Access Compliance Report Public Rights-of-Way (Curb Ramps)

Main Street: TERRACE_RD Cross Street: CORPORATE Location: NW

ADA ID: RPRK211115162658 Ramp Type: Type 4 - Parallel Initial Pass/Fail: Fail Overall Compliance: No Severity Score: 15

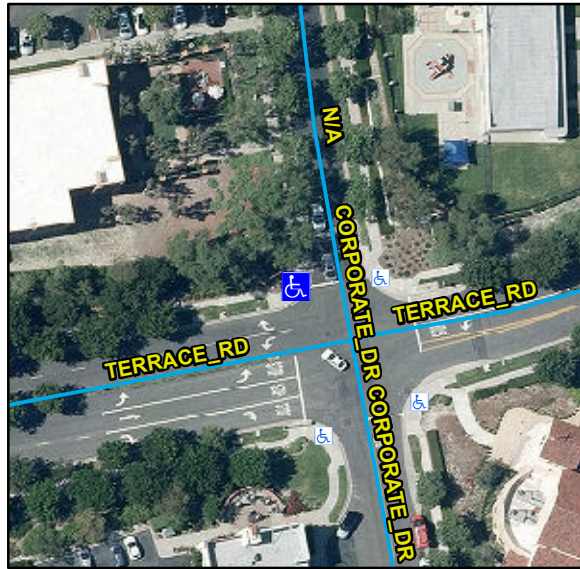
Compliance	Description	Data	Compliance	Description	Data
N/A	Ramp Length LT (in)	133	N/A	Ramp Length RT (in)	132
Yes	Ramp Width LT (in)	90	Yes	Ramp Width RT (in)	90
No	Ramp Run Slope LT (%)	9.6	Yes	Ramp Run Slope RT (%)	0.3
Yes	Ramp Cross Slope LT (%)	0.1	Yes	Ramp Cross Slope RT (%)	1.5
N/A	Landing Present	N/A	N/A	DWS Provided	N/A
N/A	Landing Length (in)	N/A	N/A	DWS Contrast	N/A
N/A	Landing Width (in)	N/A	N/A	DWS Length (in)	N/A
N/A	Landing Run Slope (%)	N/A	N/A	DWS Full Width	N/A
N/A	Landing Cross Slope (%)	N/A		DWS Offset Type	N/A
N/A	Landing Movement Obstructed?	N/A	N/A	DWS Offset Left (in)	N/A
	Landing Movement Type	N/A	N/A	DWS Offset Right (in)	N/A
N/A	Landing Shared	N/A			
N/A	Clear Space	Yes			
N/A	Clear Space To Crosswalk (in)	N/A			
N/A	Marked Crosswalk 1	No	N/A	Marked Crosswalk 2	No
	Crossing 1 Direction	S		Crossing 2 Direction	N
	Marked Crosswalk 1 Width (in)	N/A		Marked Crosswalk 2 Width (in)	N/A

Remove & Replace Curb Ramp With Two New Directional Ramps or Equivalent.
